NO.1 TRITON SQUARE

### 1.0 SUMMARY OF NMA's

NMA DESIGN REPORT

246868-A\_A-XX-GF-DR-AX-30020 Ground Floor Plan

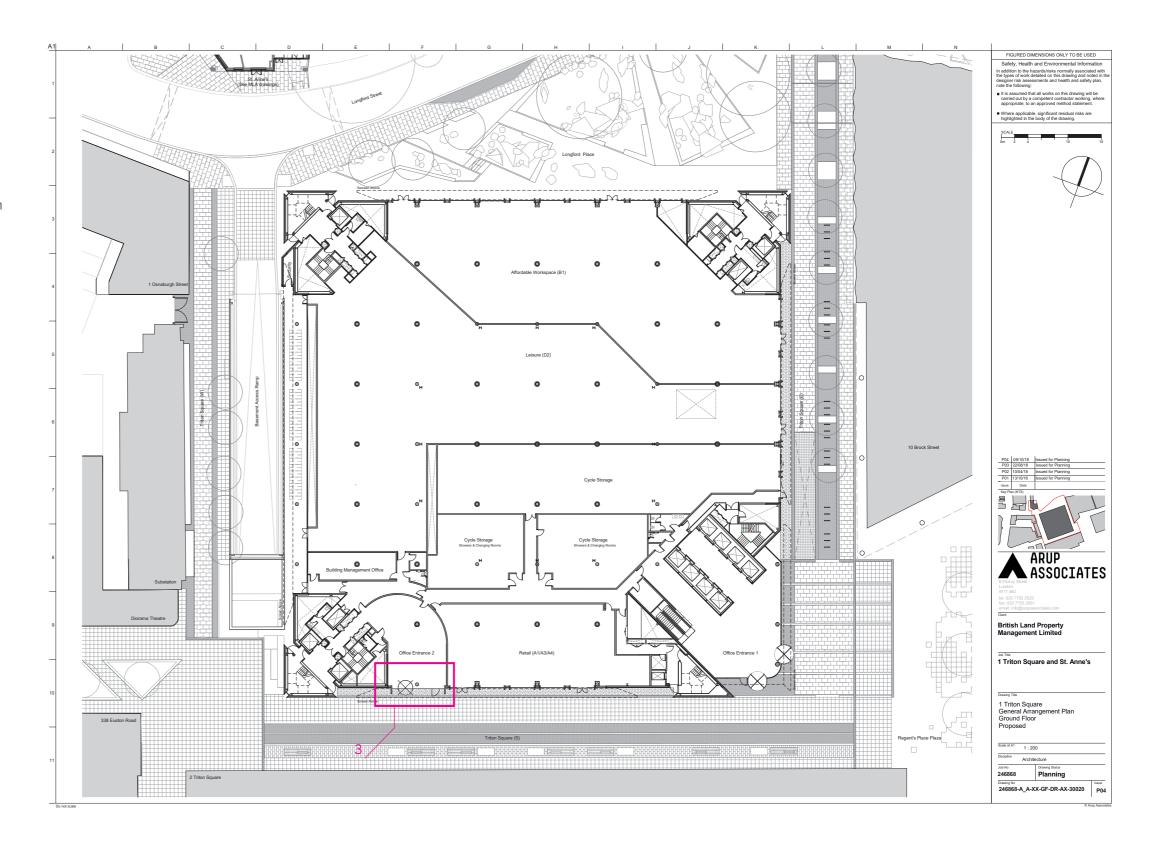
(3) The depth of Core 2 entrance has increased from 300mm to 1000mm to enhance visibility as a second office entrance. Proportions and consistency of design approach maintained.
